Work Order ID 101161

Item Name: Crosstube Turning Detail

DART AEROSPACE LTD	Work Order:	101161
Description: Crosstube Assembly (205/212/412 High Fwd)	Part Number:	D212-664-141
Inspection Dwg: D212-664-141 Rev: D		Page 1 of 2

DRAWING NO. D212-664-141	TITLE XTUBE ASSY (205/212/412 HI FWD)	REV. D	DART AEROSPACE LTD ENGINEERING ORDER		D.E.O. NO. D212-664-141-D-1	SHEET NO. SHEET 1 OF 2	SCALE NTS
DRAWN	CHECKED	OP	MFG. APPR.	BE	APPROVED	MP	DE APPR.
DATE 11.04.07	DATE 11.07.11		DATE 11.04.12		DATE 11/04/12		DATE 11.04.12

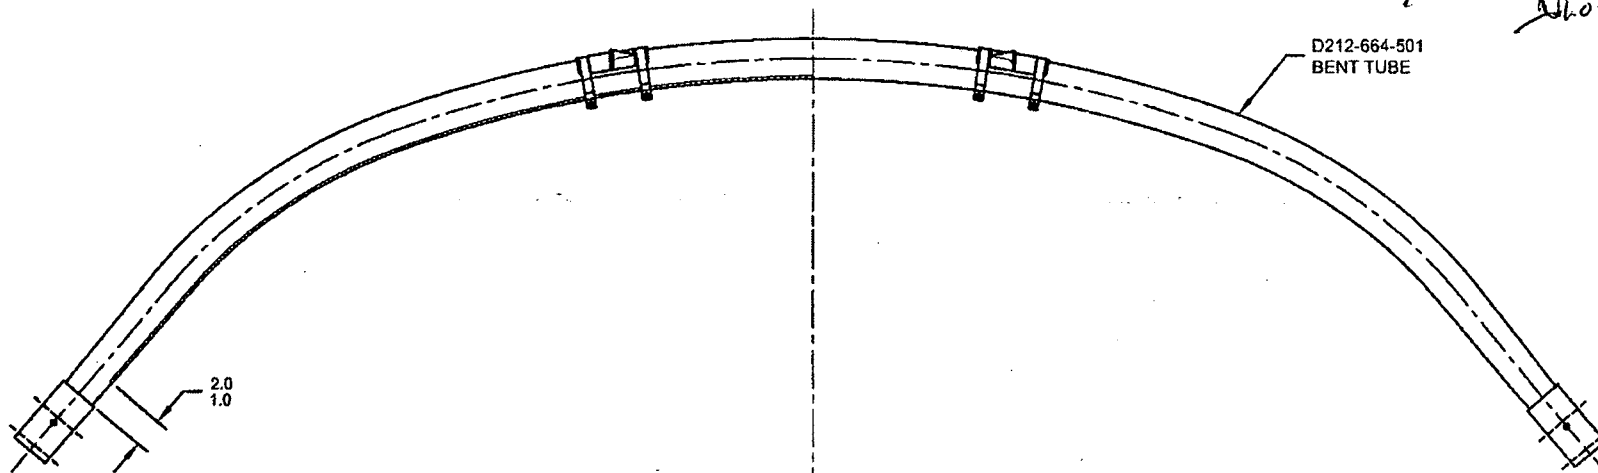
PURPOSE:

ADD AN INSPECTION WINDOW TO UNDERSIDE OF CROSSTUBE.

IS:WAS:~~UNDER REVIEW~~*JP 11/06.13*~~ECN# 11-614~~*11.07.28*D212-664-501
BENT TUBE**D212-664-141/-141B**
ASSEMBLY DETAILMASK AREA PRIOR TO PAINTING,
REMOVE MASKING AFTER PAINT
AND APPLY CLEAR COAT

- 2) FINISH: CHEMICAL CONVERSION COAT PER DART QSI 005 4.1
PRIME INSIDE AND OUTSIDE PER DART QSI 005 4.2
MASK UNDERSIDE OF CROSSTUBE AS SHOWN (HATCHED AREA) AND
PAINT OUTSIDE PER DART QSI 005 4.2
REMOVE MASKING AND APPLY CLEAR COAT
